TRUCK, AMBULANCE, LIGHT, 4 LITTER, FFR, WINCH, MC2 - LAND ROVER 110 6 x 6
TRUCK, ELECTRONIC REPAIR, LIGHT, MC2 - LAND ROVER 110 6 x 6
TRUCK GENERAL MAINTENANCE, LIGHT, WINCH, MC2 - LAND ROVER 110 6 x 6

FITMENT OF A HEAVY DUTY INDICATOR FLASHER UNIT

MODIFICATION INSTRUCTION

FIG 1 - INDICATOR FLASHER UNIT CONNECTOR WIRING

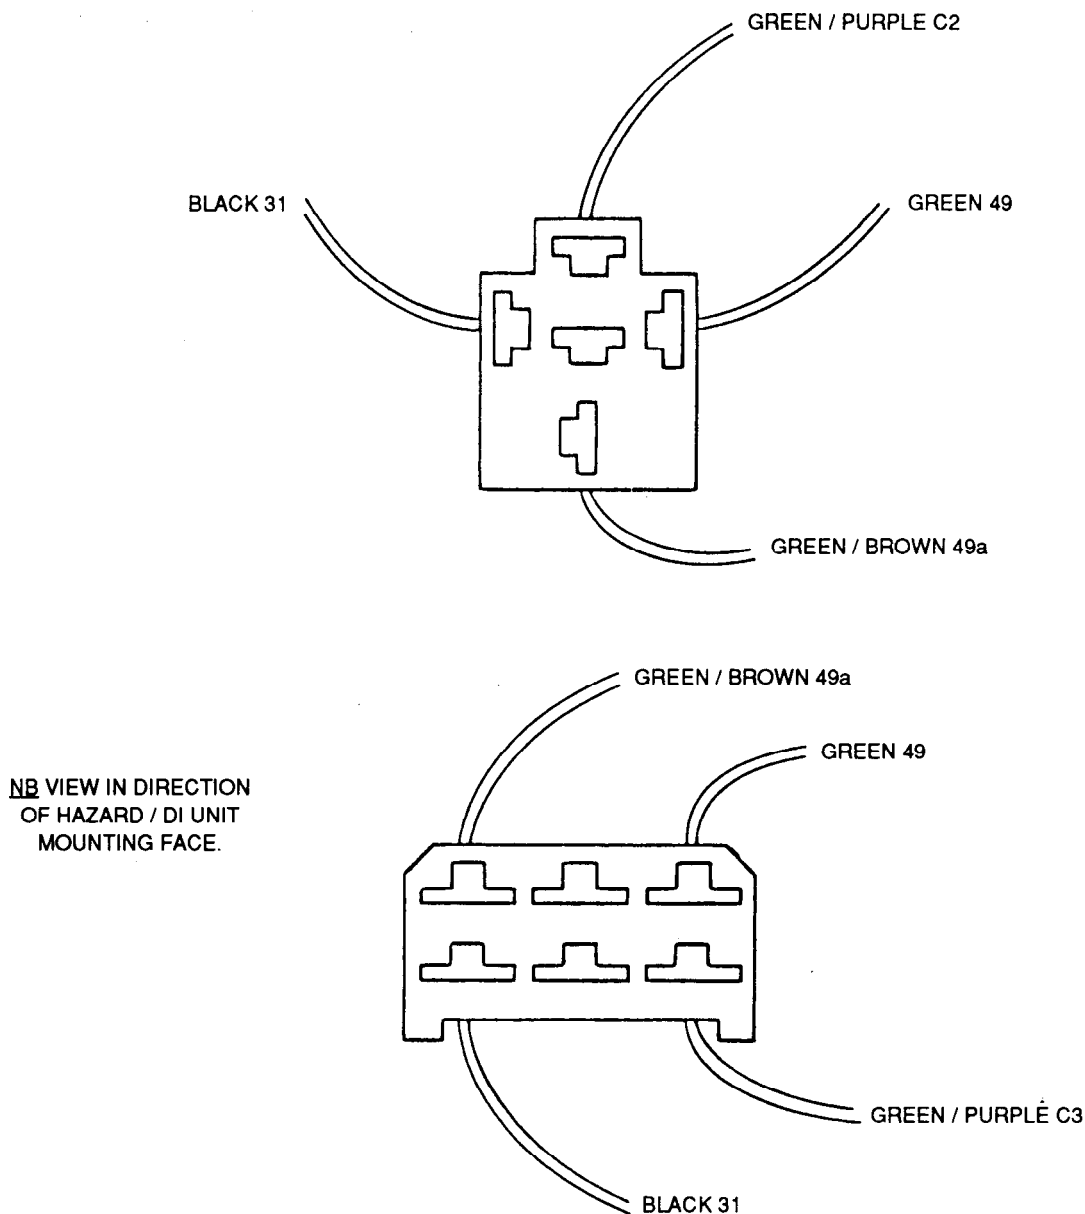
7. The modification is to be carried out as follows:
 - a. Disconnect the vehicle battery.
 - b. Remove the fuse panel cover.
 - c. Remove the two screws securing the fuse box mounting plate to the bulkhead and pull the plate gently outwards to provide access to the indicator flasher unit.
 - d. Remove the flasher unit securing screw and disconnect the wiring connector plug.
 - e. Remove the four terminals from the connector plug by carefully inserting a narrow blade screwdriver into each connector aperture to release the lock tab.
 - f. Refit the terminals to the new connector plug (item 1 from Table 2) as shown in Fig 1.

1. Ensure the wires are refitted correctly or wire burn out will occur.

- g. Connect the plug to the new flasher unit (item 2 from Table 2).
- h. Refit the flasher unit to the fuse panel.
- i. Refit the fuse panel mounting plate to the bulkhead and secure the fuse panel cover.
- j. Reconnect the battery and check the flasher unit operation.
8. Modification Record Plate. Deface the numeral 11 on the modification plate located on the drivers seat base including the vehicles modified in production.
9. Recording. Enter the details of the modification in Part 3 of the TGM 120, Record Book for Service Equipment, for the subject vehicles, including the vehicles modified in production.
